Re: Response to Comment Letter Dated October 8, 2020; Application for Modification 20-1 to Mt. Taylor Mine, Permit No. CI002RE, Rio Grande Resources Corporation

This letter is Rio Grande Resources Corporation's (RGR) response to a comment letter by the New Mexico Mining and Minerals Division (MMD) dated October 8, 2020. The letter contained comments on RGR's request for permit modification submitted May 15, 2020. The modification request application was assigned the identifier of "MOD 20-1" by MMD. RGR's permit modification request addressed an update to the reclamation schedule, the expansion of the disposal cell in the south waste rock pile and a proposed modification of the disposition of several structures for the Post Mining Land Use (PMLU).

Responses to MMD's Comment Letter of 10/8/20

SHEET NO.
CL- 04A

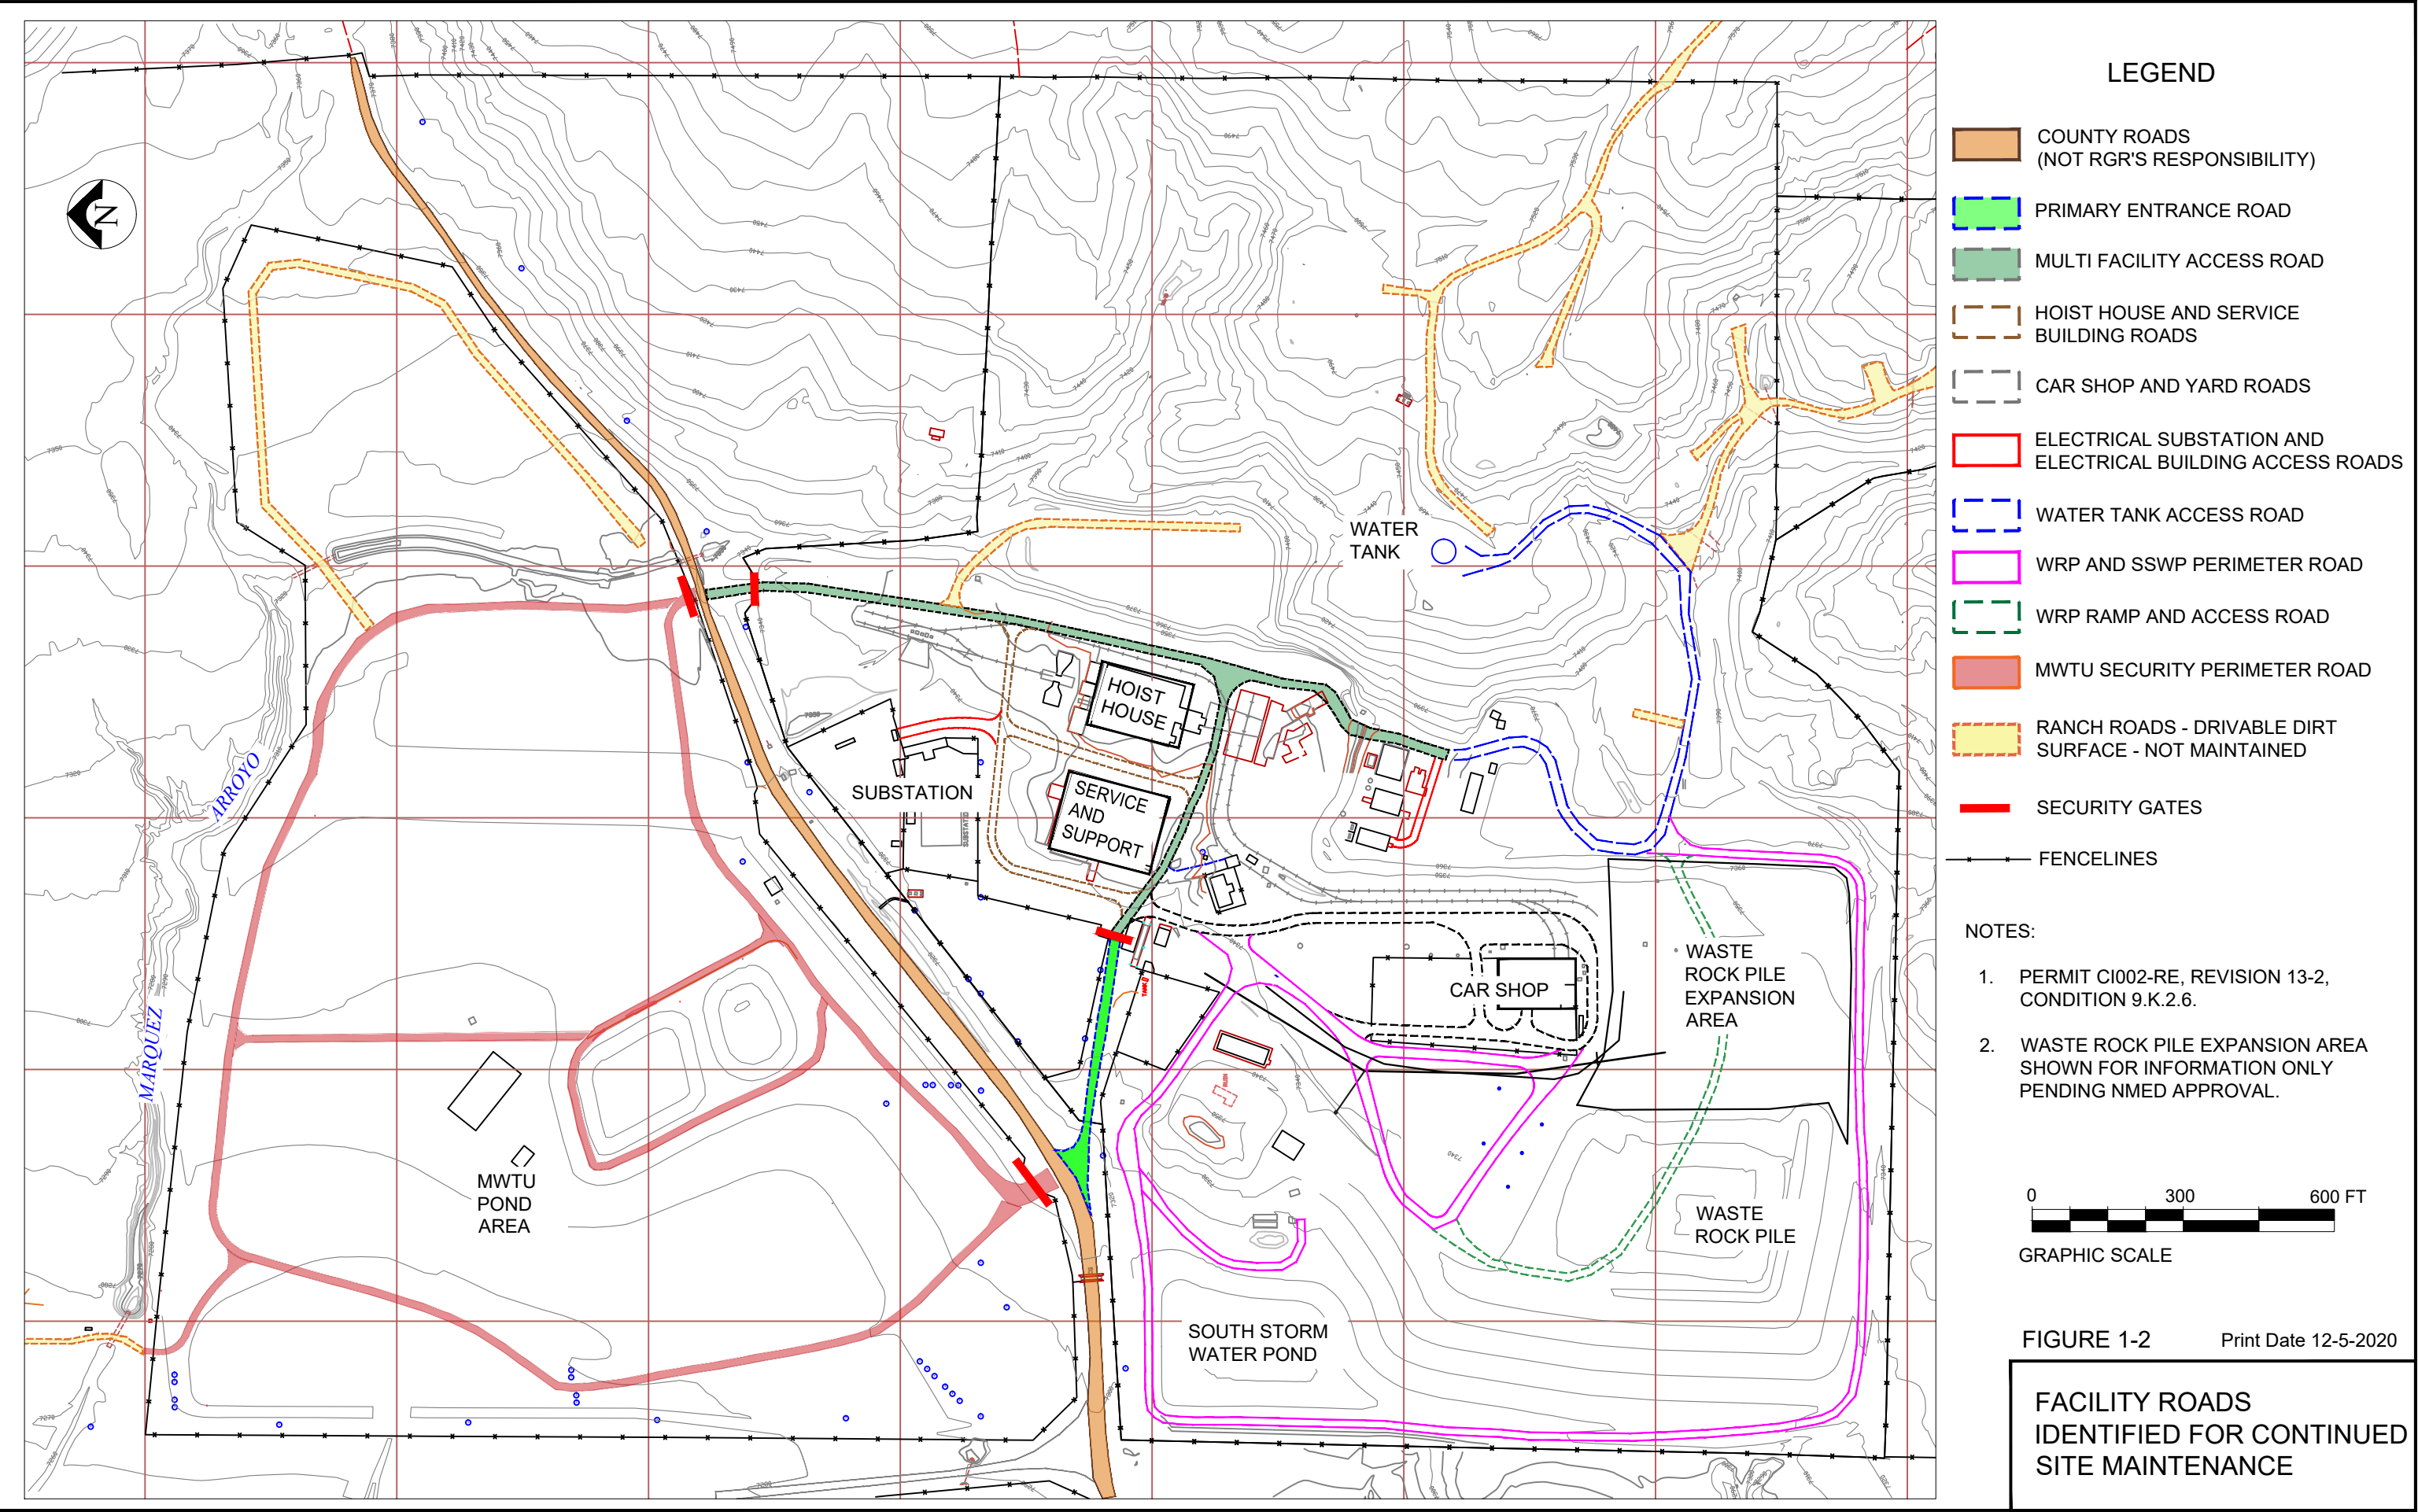
17. *Section 4.5, Requested Changes to the Approved PMLU, page 9 of the Application refers to Table 5.1, Building List – Demolish and Retain. This section also lists the facilities that RGR proposes to retain during the mine closeout and abatement activities including the Phase I and Phase II Dewatering Wells. Table 5.1 also lists Phase III Water Wells. Please provide the well numbers and locations of all of the Phase I, II, and II wells on a map, the depth of each well and the geologic formation and aquifer that each well is completed. In addition, please specify the proposed disposition for each well under the mine closeout plan and the Application.*

Please refer to the attached drawing titled "Dewatering Well Disposition Plan" (Dwg No. GS20-CL104-00, Sheet No. CL-04A).

SHEET NO.
CL- 04

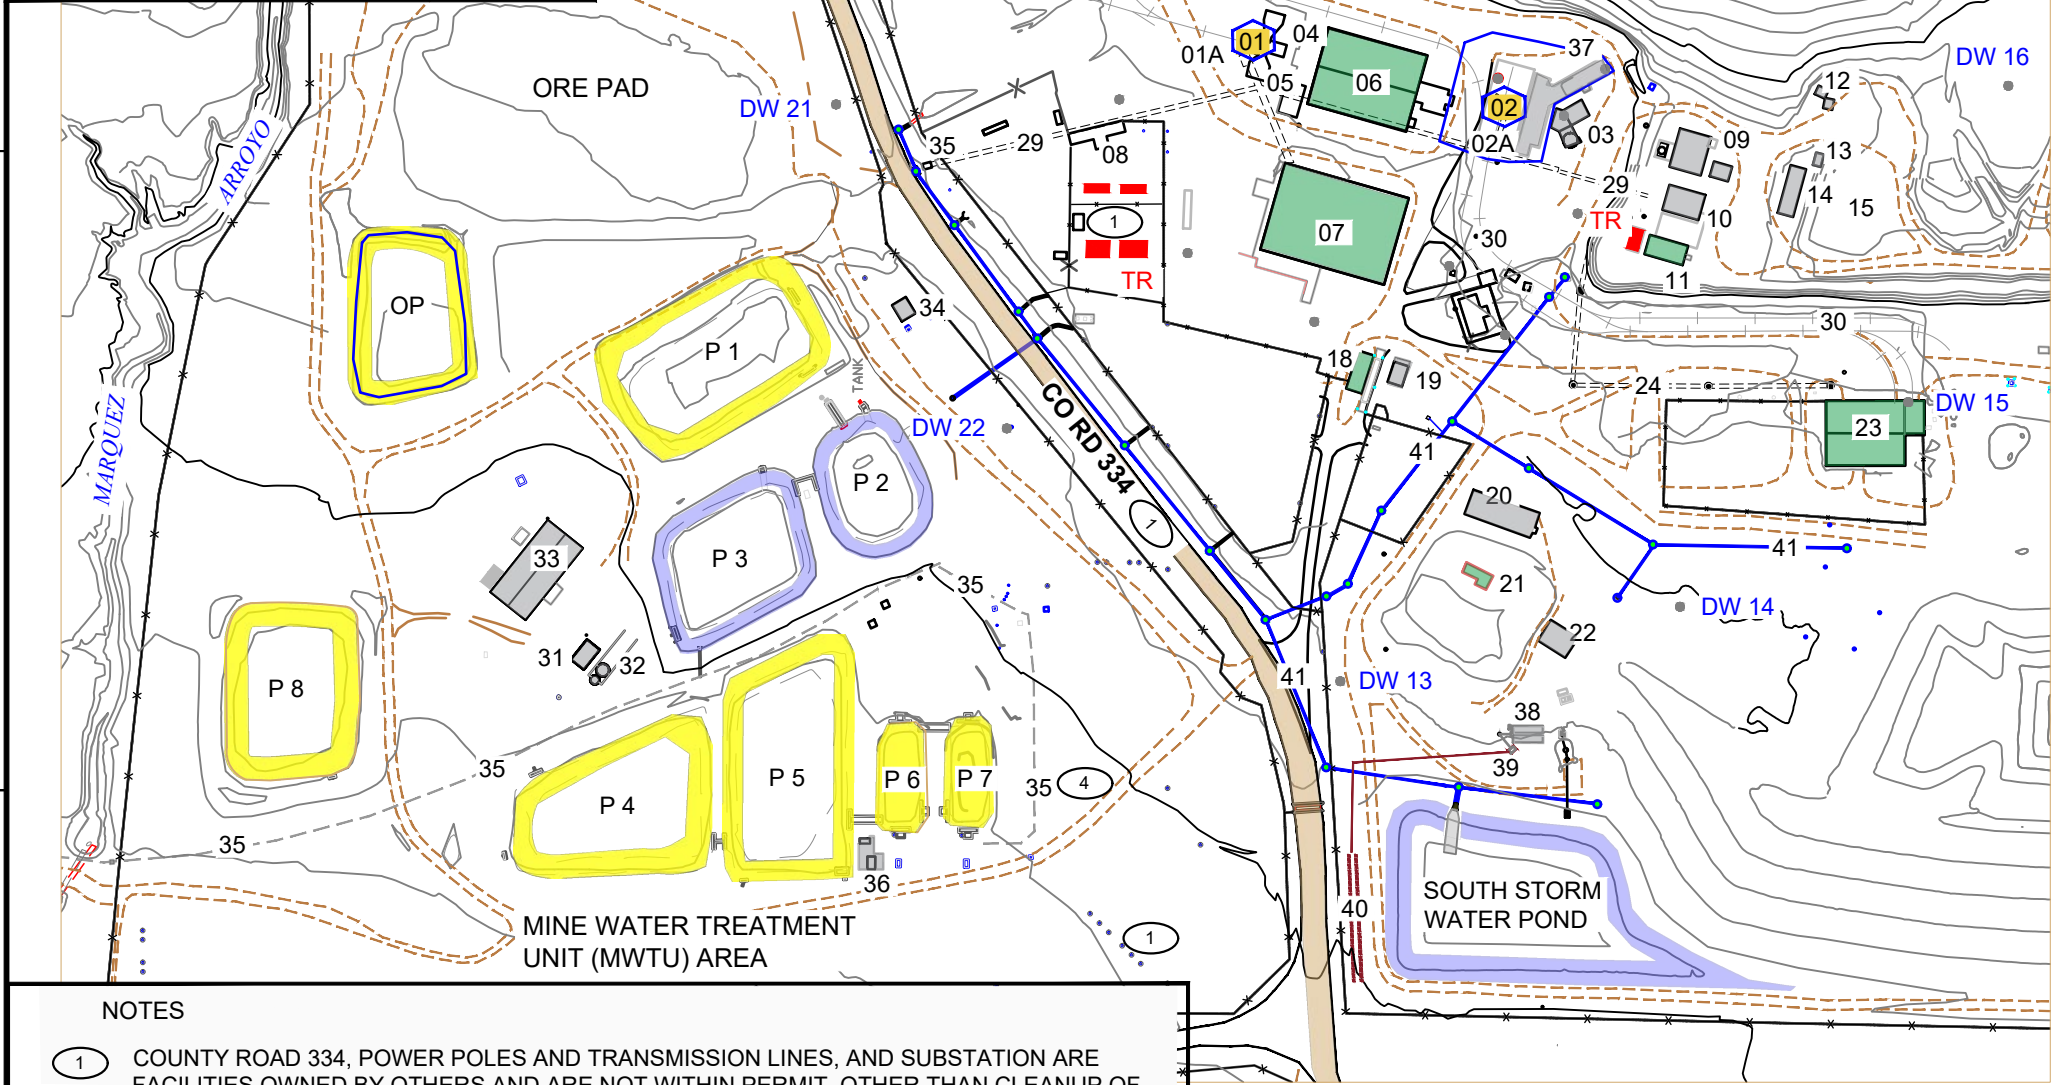
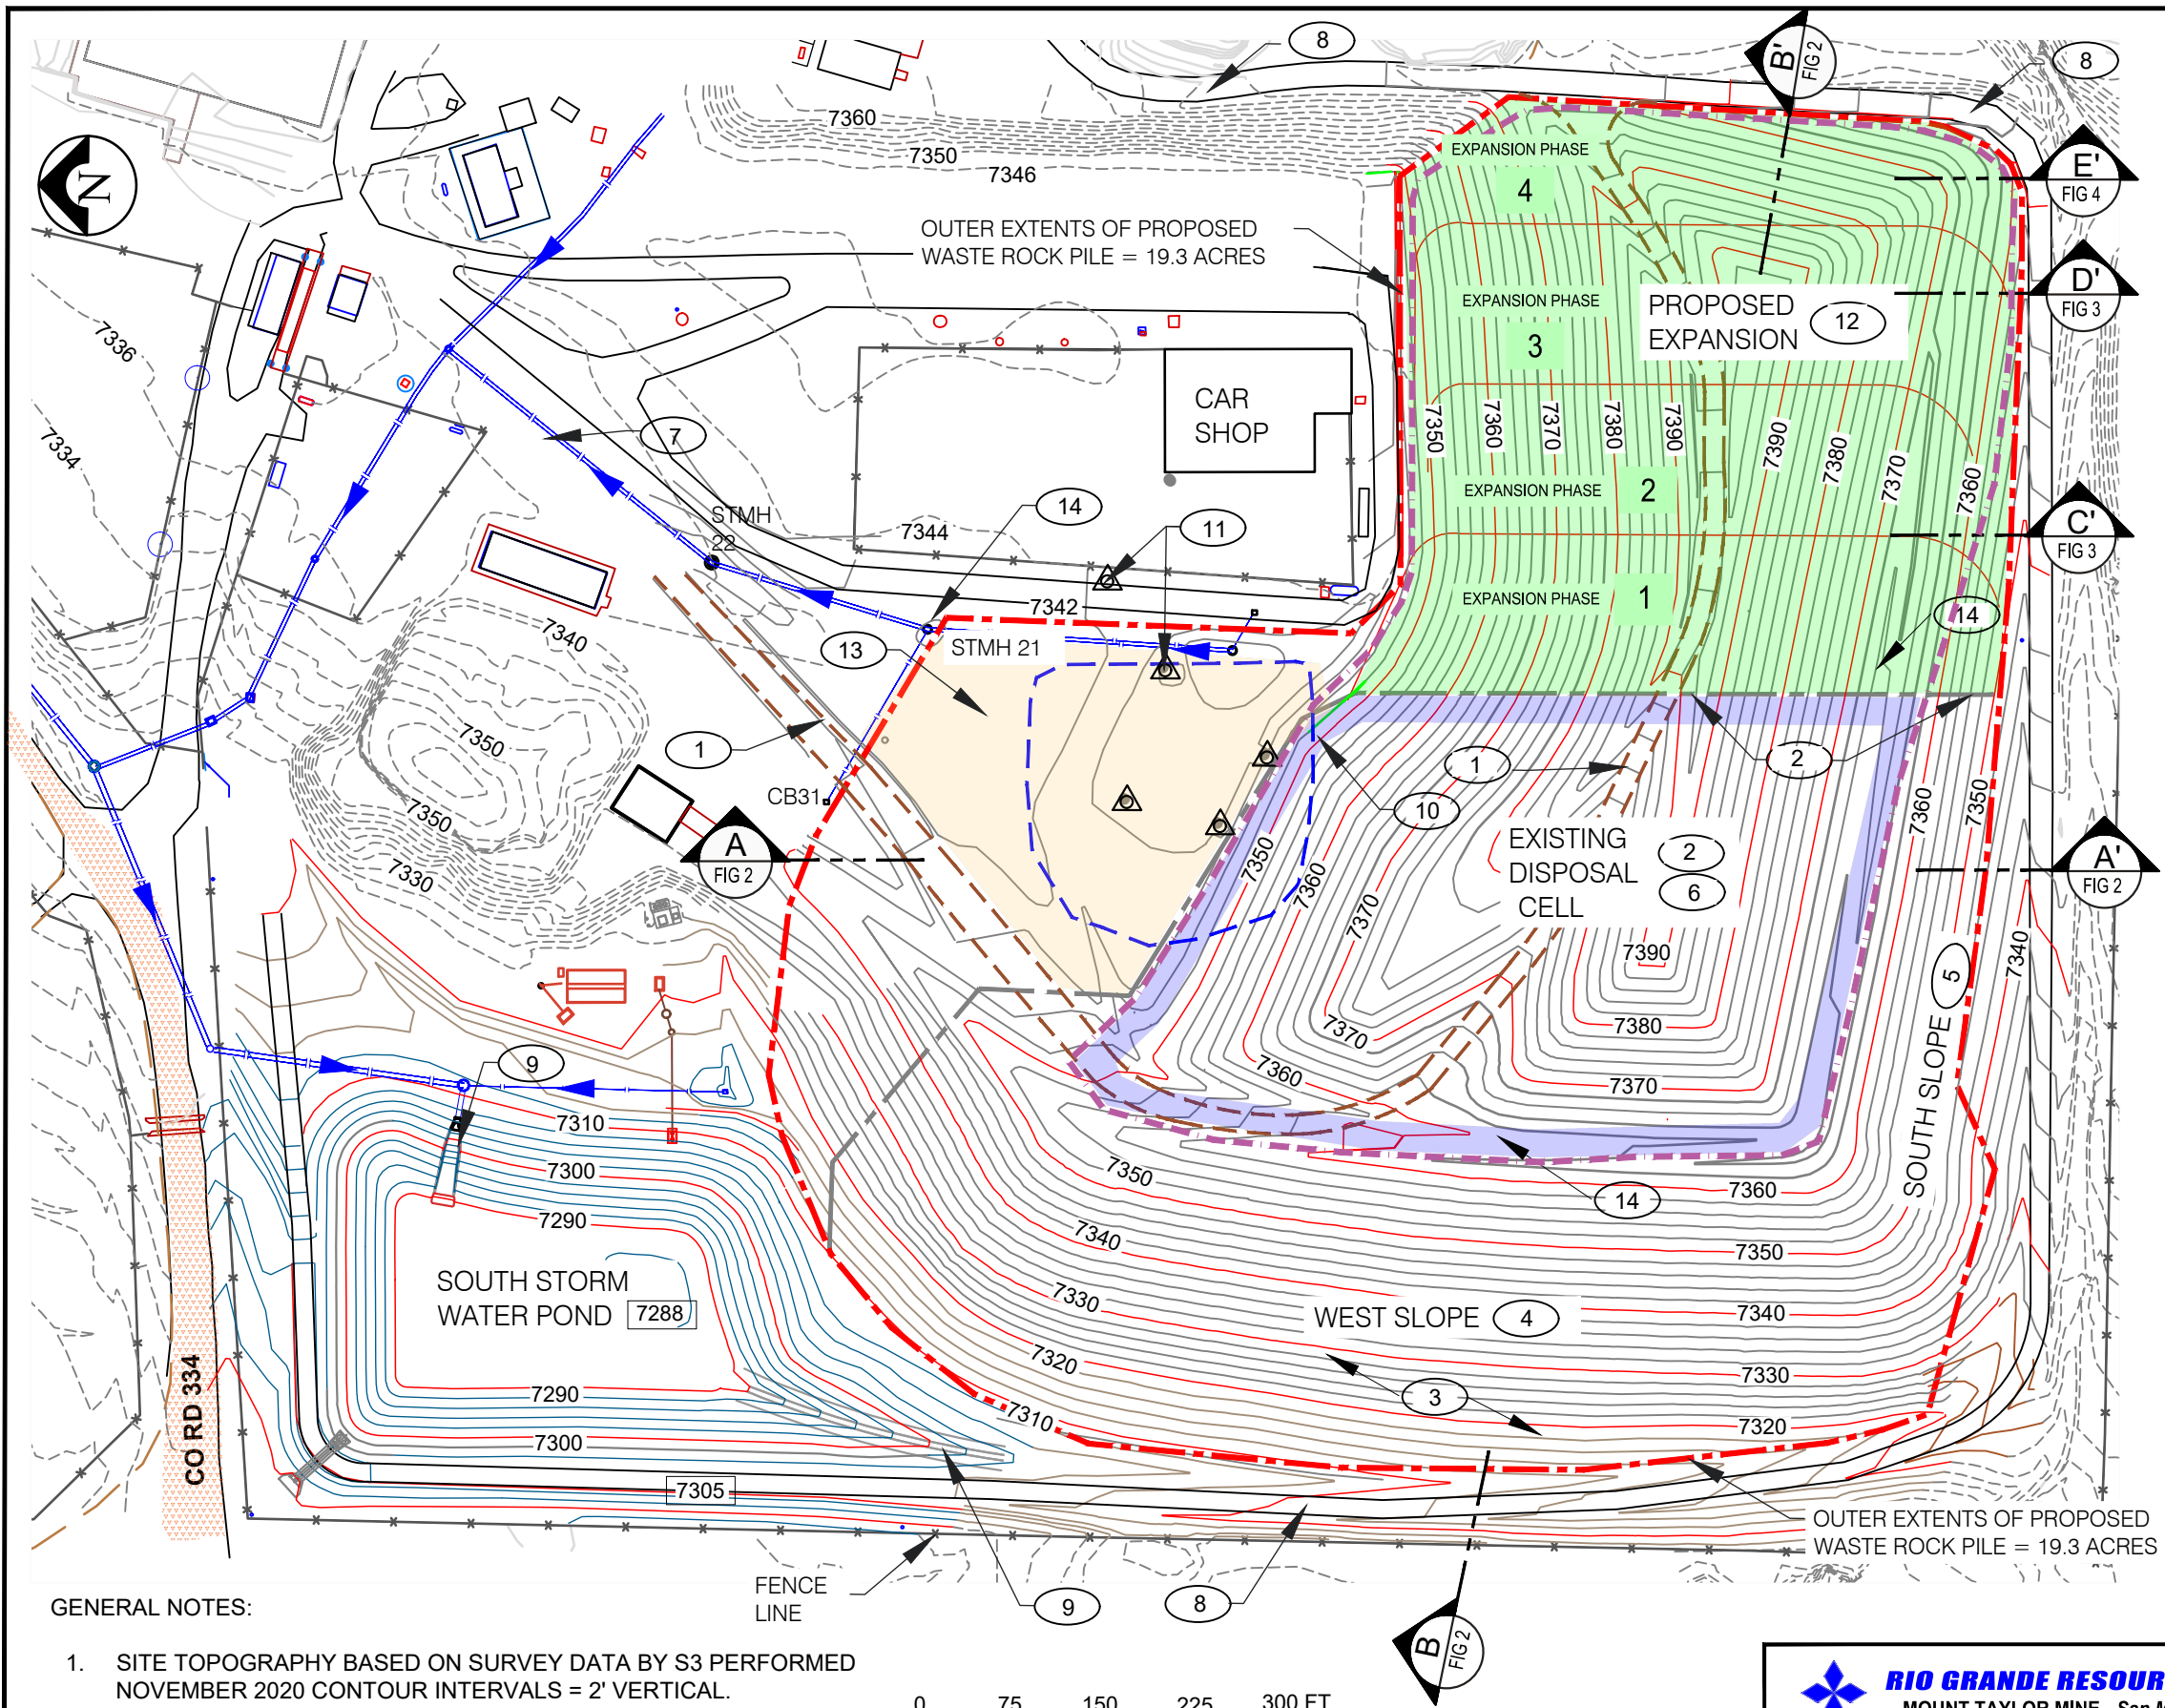
19. *Table 5.1, Building List – Demolish and Retain of the Application lists the currently approved Disposition at Closeout for the buildings and facilities at the mine. Please provide a drawing of the mine site with these buildings and facilities labelled.*

Please refer to the attached drawing titled "Facility Disposition Plan" (Dwg No. GS20-CL104-00, Sheet No. CL-04).
